Subject: REVISION - N202315730-01 - Service Update
Wheel Casting with Exposed Porosity
Revised Service Procedure

Models: 2020 - 2021 Chevrolet Corvette

N202315730 Wheel Casting with Exposed Porosity

Revision: 01

Back Side of Spoke near Rim:

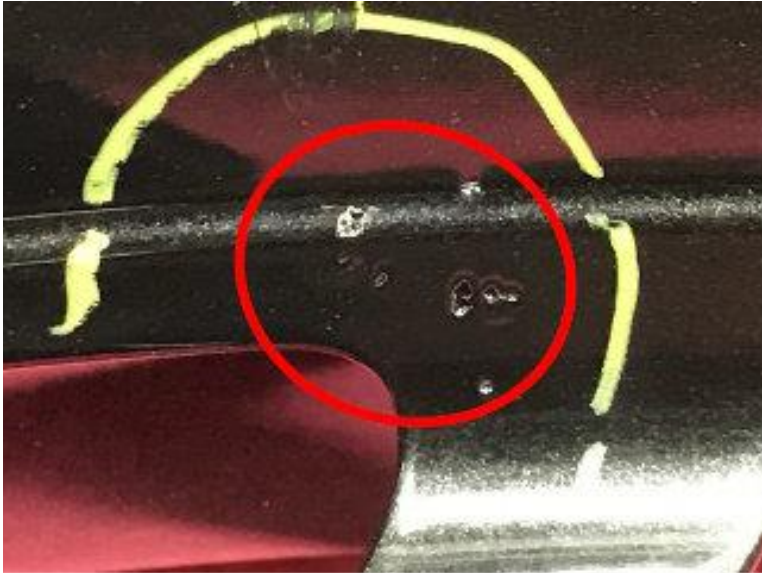
3. If required, clean the wheels using an appropriate cleaning solution. Use care to not damage the wheels with non-approved cleaners.
4. Thoroughly inspect the front side, back side, and rim of the wheels for porosity in the surface of the metal. Porosity examples are shown below in circles.

The following photos show examples of the porosity condition covered by this bulletin.

Note: Each wheel must be individually and thoroughly inspected to avoid invalid submissions. Do NOT automatically replace all four wheels on the vehicle.

5. If any of the above conditions are found, initiate the Pre-Repair Authorization (PRA) process for a wheel replacement authorization:
